LiDAR Quality Assessment Report

VA-MD-WV FEMA-LIDAR-R3Lot5 2012

FEMA Region3 VA LiDAR

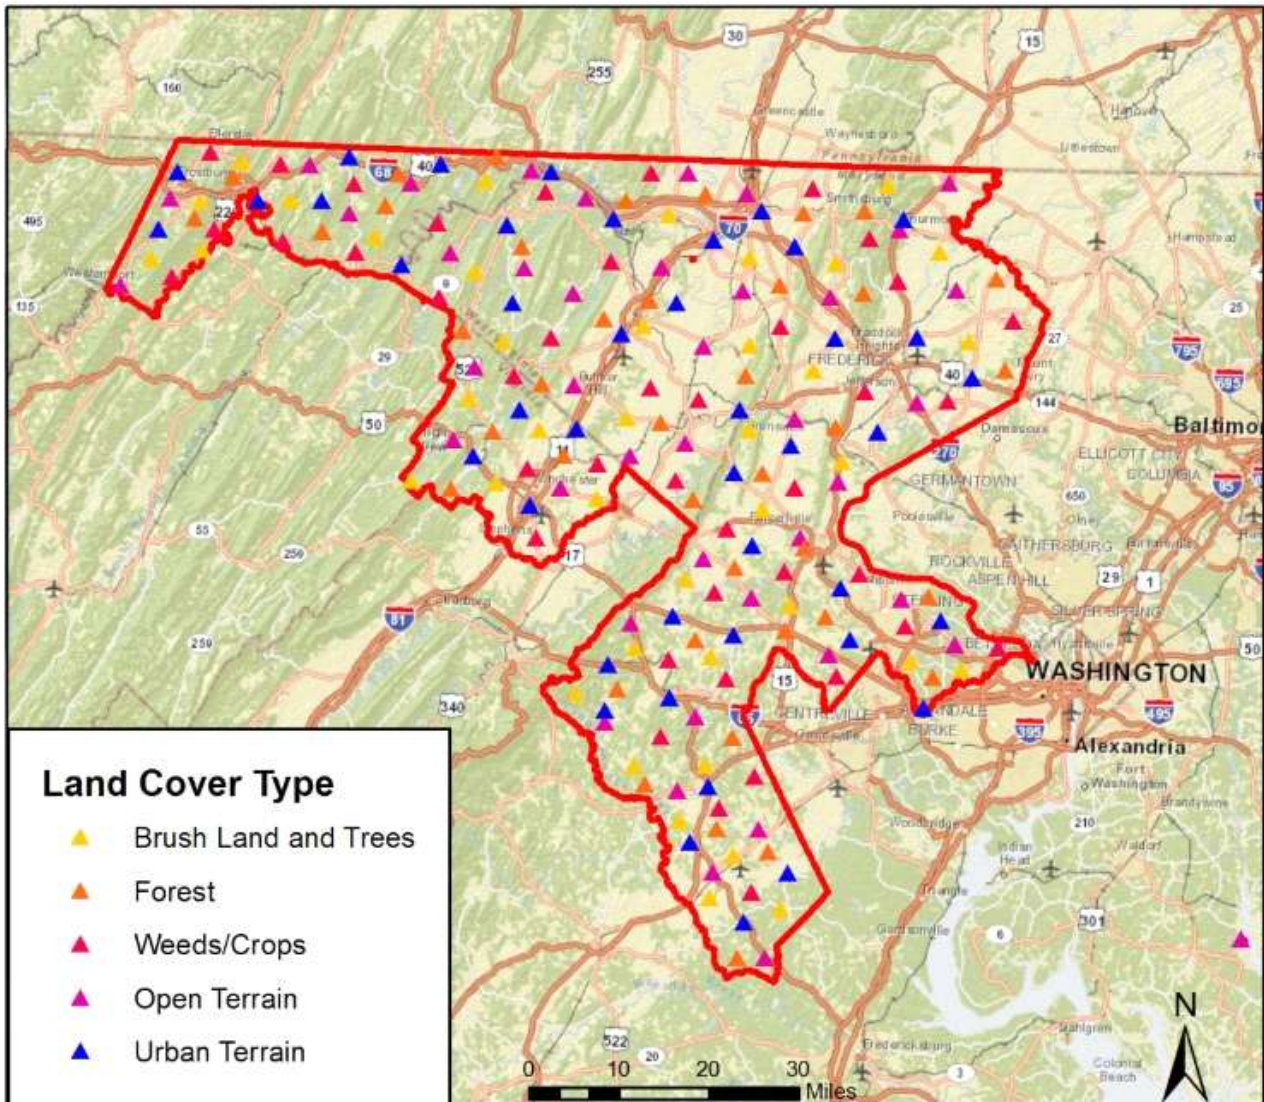
Figure 2 – Checkpoint Map shows that checkpoints are well distributed throughout project area.

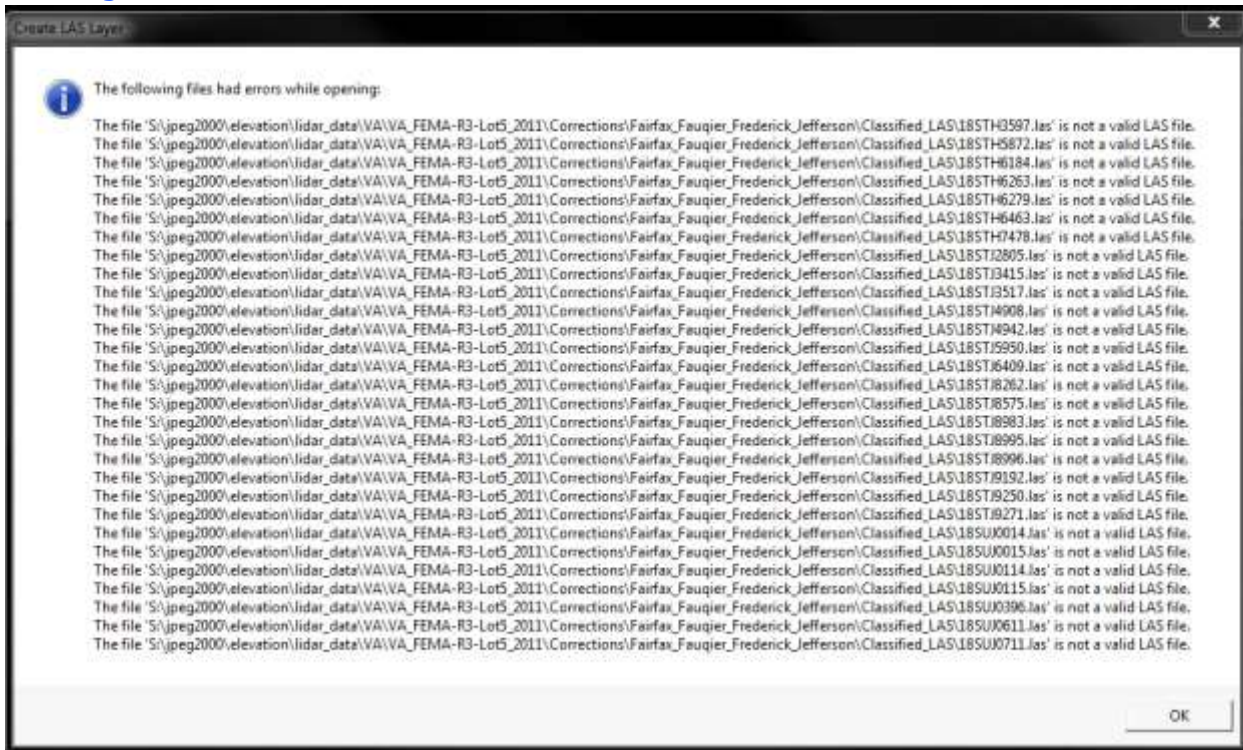
Page 11 of the "Project Report for the Fauquier, Fairfax, Frederick, and Jefferson County Acquisition and Classification for FEMA Region 3 FY 12 VA Lidar" reports the classification scheme as 1, 2, 7, 9, 10, and 11 however the following classified las tiles contain points classified as 15:

Corrections delivered 2/8/13, however, reviewer unable to load in ArcMap or in standalone LP360. Please see image at end of LAS Tile File Review section of report. Telecon on 2/26/13, discussed downgrade of LP360 responsible for error, all classified las files accepted 2/28/13.

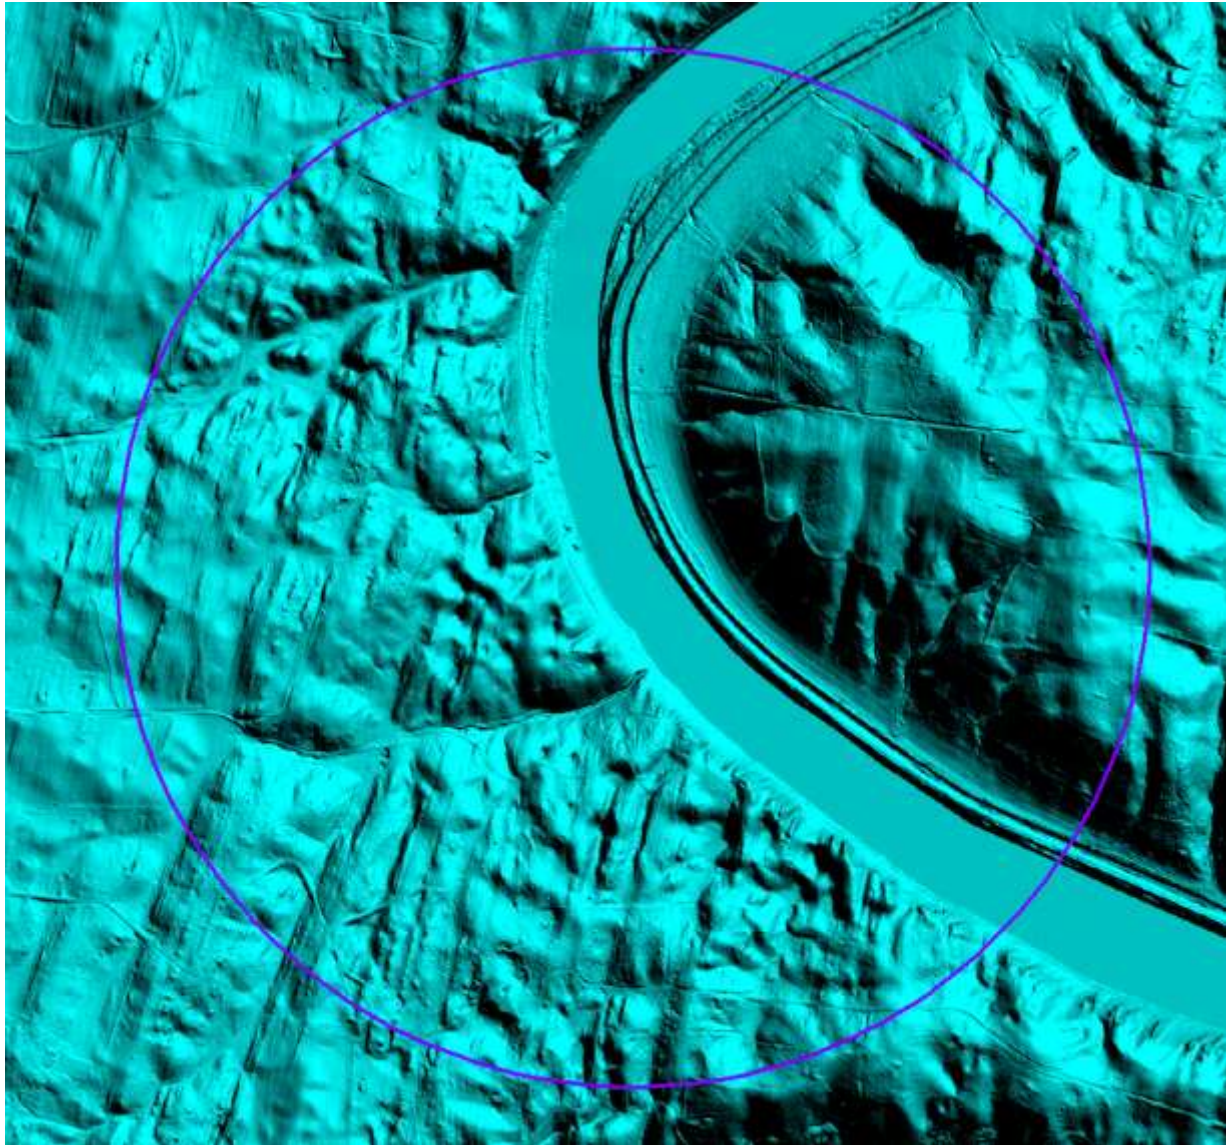
No breaklines delivered to reviewer at NGTOC for this water feature which has been correctly hydroflattened. This is acceptable as the DEM requirements were adhered to. This anomaly is documented in a shapefile created by the reviewer at the NGTOC documenting the geographic locations of errors and anomalies identified during DEM review named DEM_errors.shp. Corrections received 2/8/13, accepted 2/28/13..

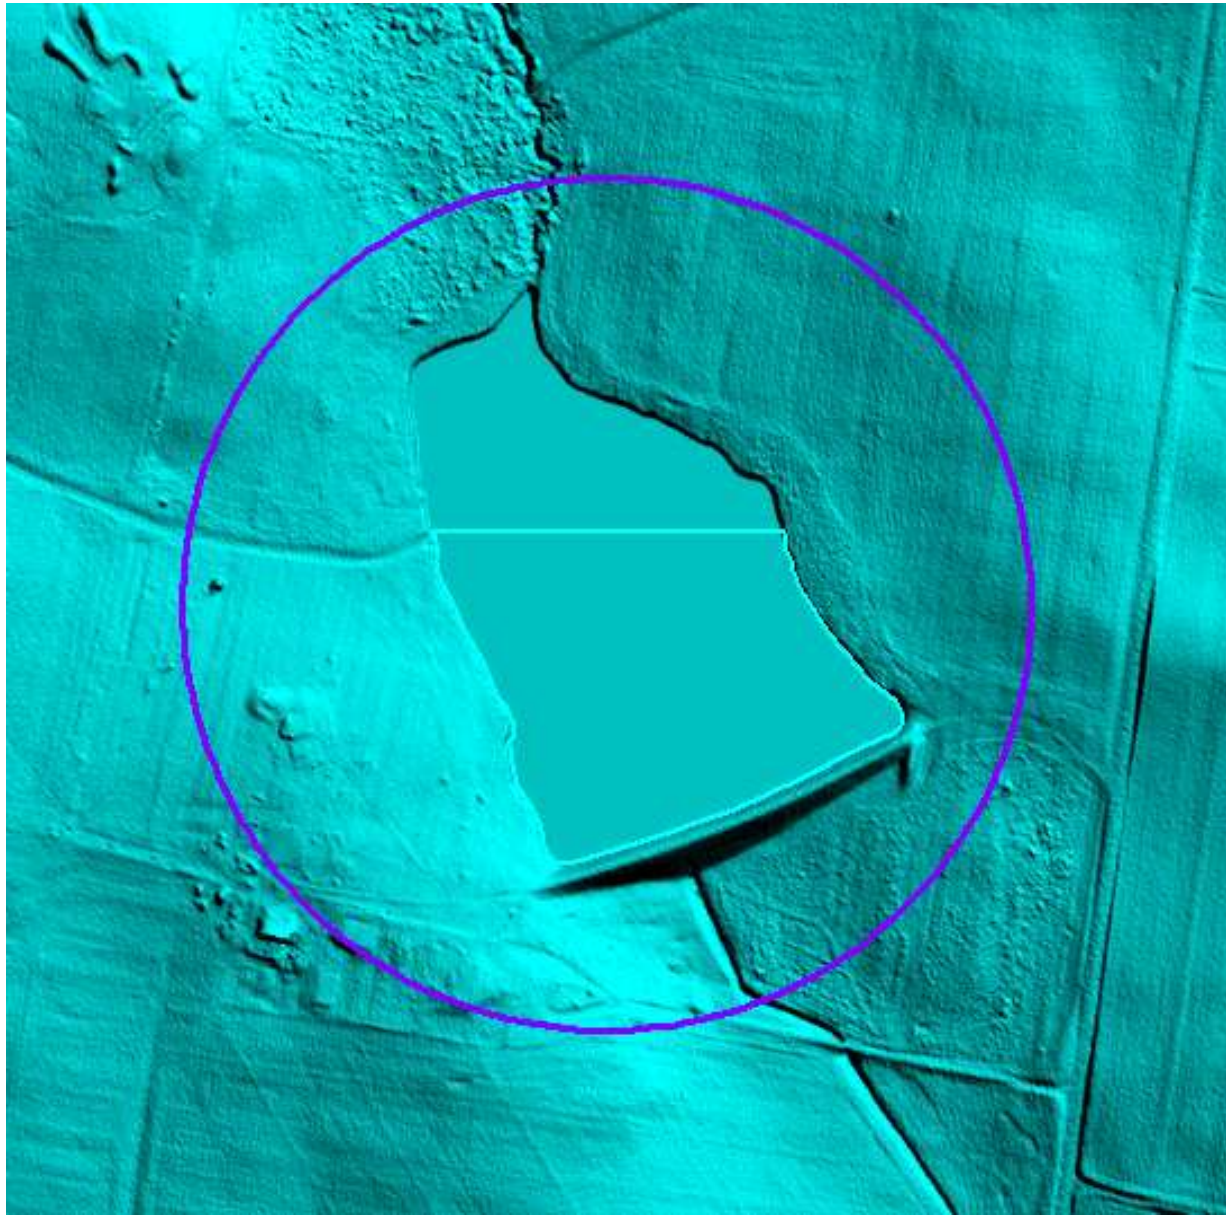
Misplaced breakline, however, feature has been correctly hydroflattened. This is acceptable as the DEM requirements were adhered to. This anomaly is documented in a shapefile created by the reviewer at the NGTOC documenting the geographic locations of errors and anomalies identified during DEM review named DEM_errors.shp. Corrections received 2/8/13, accepted 2/28/13.

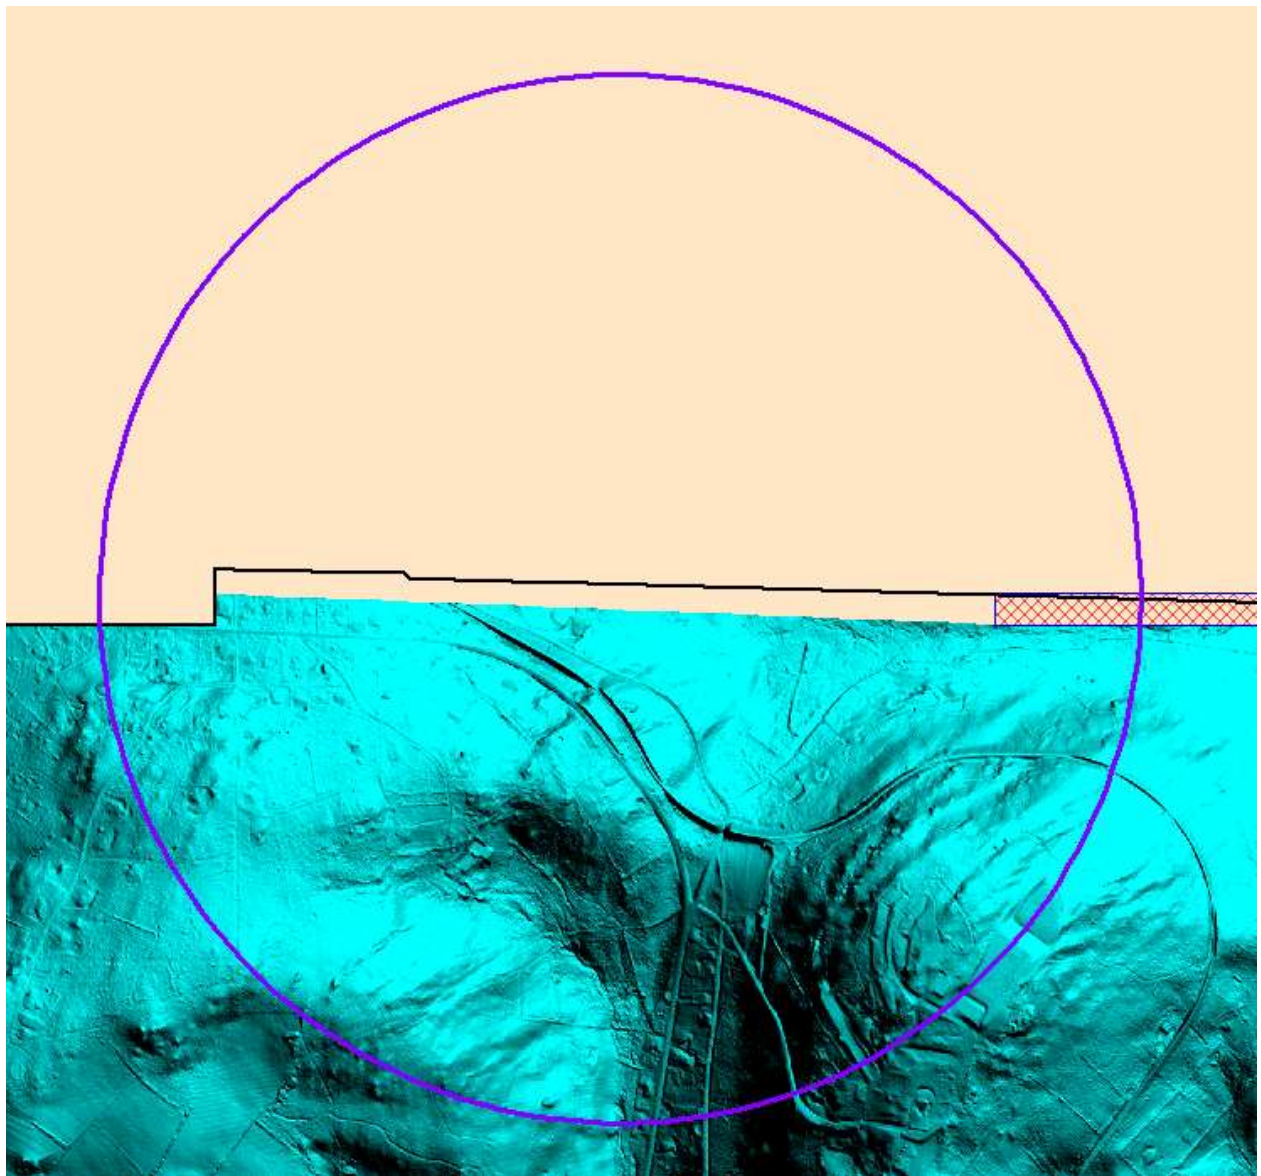
It is important to note that the reviewer performed accuracy calculations on the ENTIRE FEMA R3 PROJECT AREA. The numbers reported in the blue box above pertain to the ENTIRE FEMA R3 PROJECT AREA. THE ENTIRE FEMA R3 PROJECT AREA MEETS VERTICAL ACCURACY TESTING REQUIREMENTS.

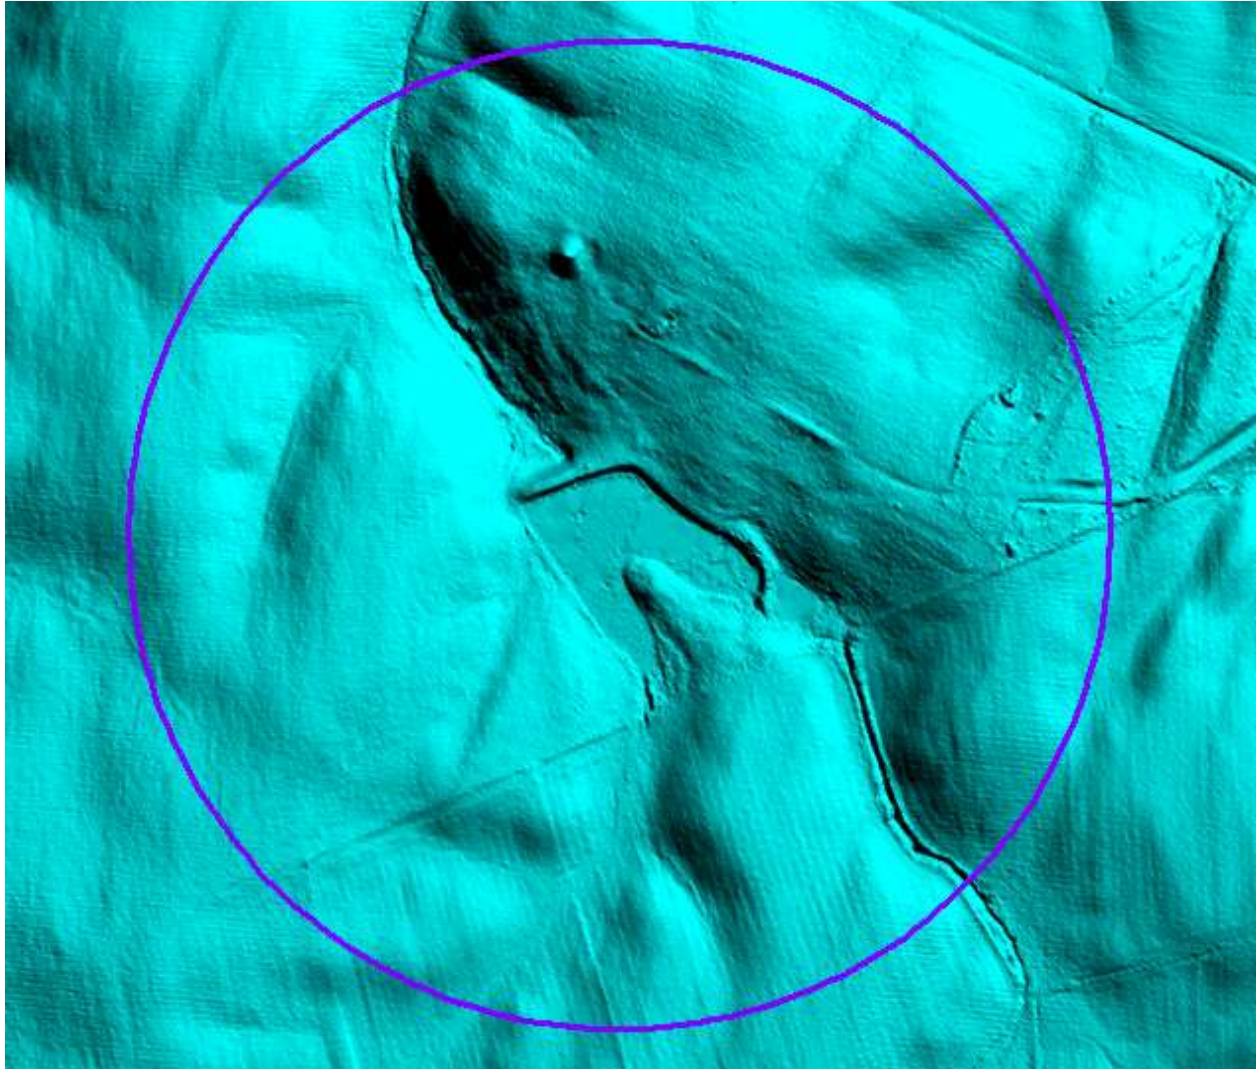
Waterbody greater than 2 acres in area not hydroflattened. Task order requires hydroflattening of all waterbodies greater than 2 acres in area. Scale 1:4568. Reviewer at NGTOC created a shapefile documenting the geographic location of errors identified during DEM review. The file is named DEM_errors.shp and is located in the NED-Errors folder. Corrections received 2/8/13, accepted 2/28/13.

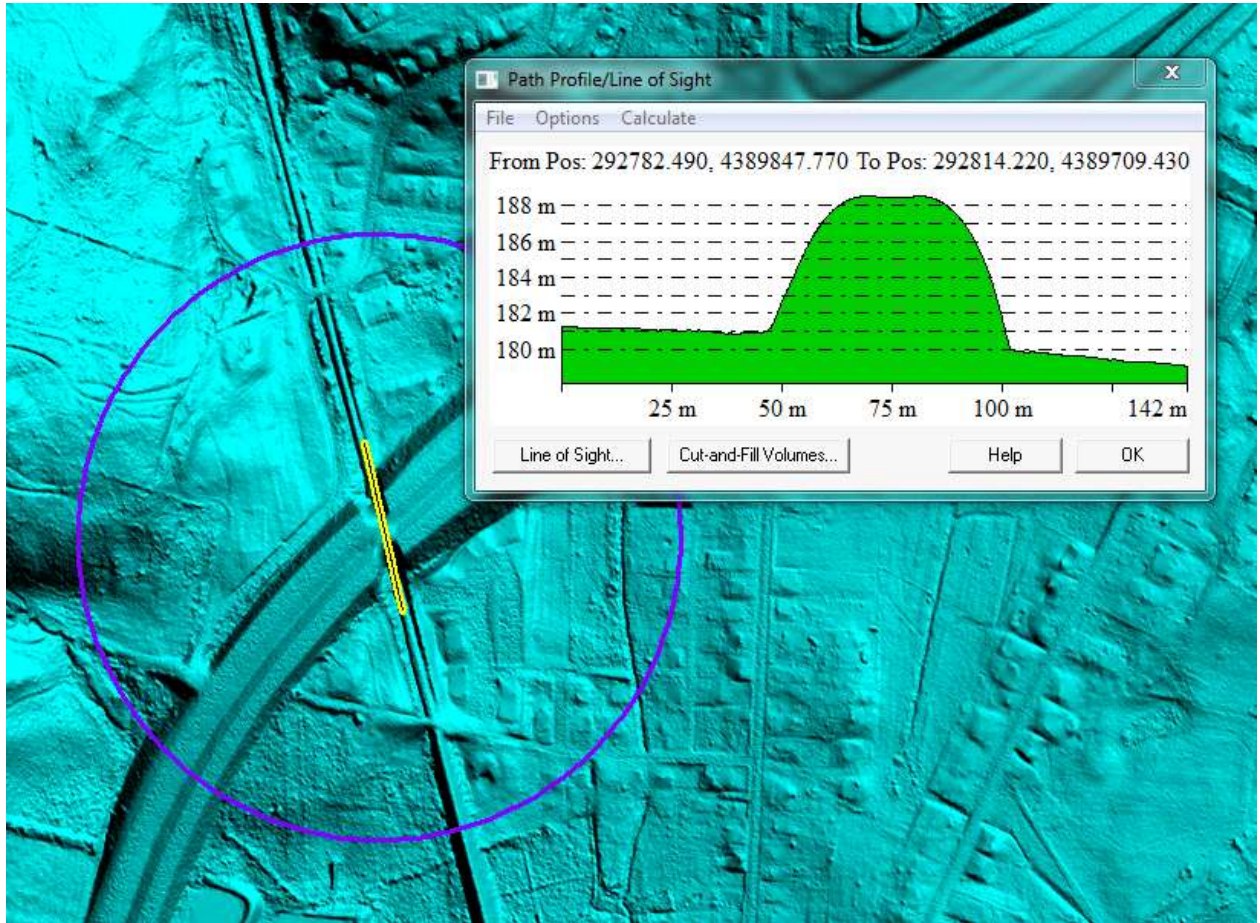
Bridge not completely removed from bare earth surface. Scale 1:10438. Reviewer at NGTOC created a shapefile documenting the geographic location of errors identified during DEM review. The file is named DEM_errors.shp and is located in the NED-Errors folder. Corrections received 2/8/13, accepted 2/28/13.
